TECHNICAL ORDER No.01-100LAA-23

30 March 1950

INSTALLATION OF HC12X20-7B PROPELLERS - L-17A (RYAN)

Figure 1 - Nose Cowl Rework

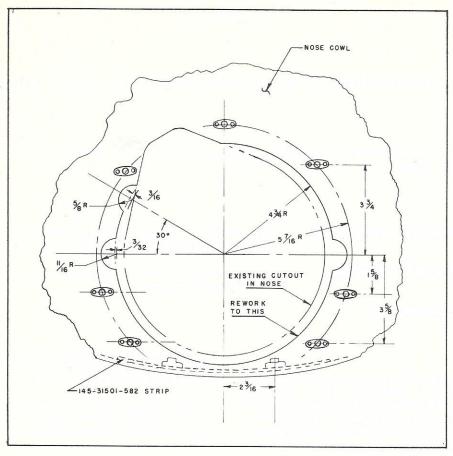
- b. Rework of cowl.
- (1) Rework cut-out in cowl assembly, part No. 145-31501-519, according to dimensions given in figure No. 1.
- (2) Lay reinforcing strip, part No. 145-31501-582, on upper nose cowl air entrance flange; using the reinforcing strip as a template, drill five (No. 30 drill) holes and secure reinforcing strip to flange with five rivets, part No. 2R1AD4-5.

Figure 2 - HC12X20-7B Propeller Installation

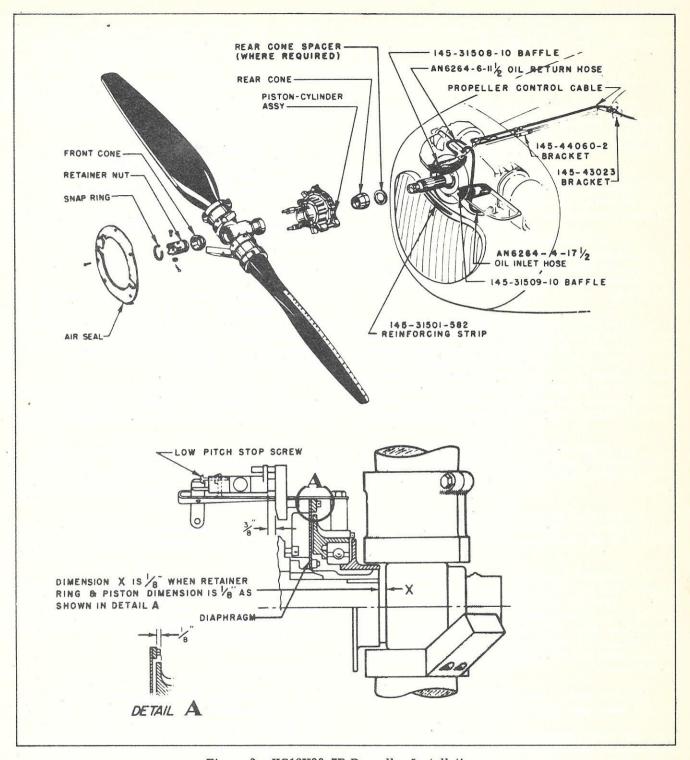
- (4) Replace nose cowl baffle seals with new baffle seals, part Nos. 145-31508-10 and 145-31509-10.
 - c. Installation of HC12X20-7B propeller.
- (1) Use nuts, bolts, and washers removed from forward bracket, part No. 145-43023, to install bracket, part No. 145-44060-2, on right side of engine. (See figure 2.)

- (8) Connect propeller push-pull control to valve lever A-117 by first positioning the piston front face 1/8 inch forward of forward face of diaphragm outer bolting ring. Then position servo valve body 3/8 inch from valve plate (figure2) and pull propeller push-pull control 1/8 inch out from full forward position. Align clevis end of propeller control and connect to A-117 lever.
